Amendment #3

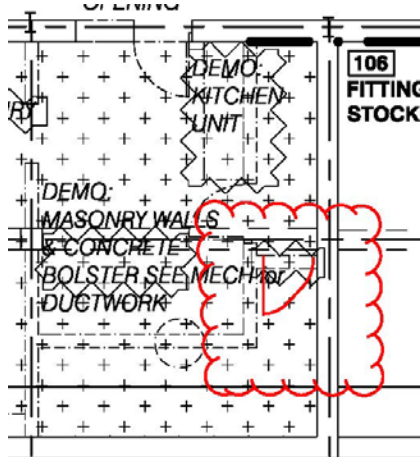
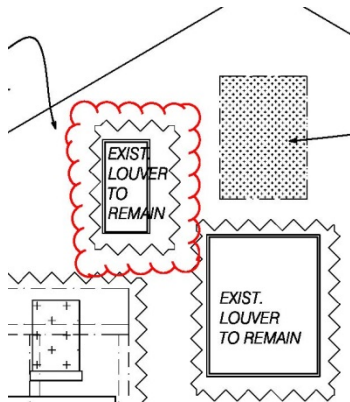
2. Demolish door and frame in record room.
3. Remove window 213 and related demolition work entirely from this project.
4. Provide 76" x 104" Louver on east side of the building. See drawing 1/A051.
5. Replace 30" x 92" louver on west side of the building.
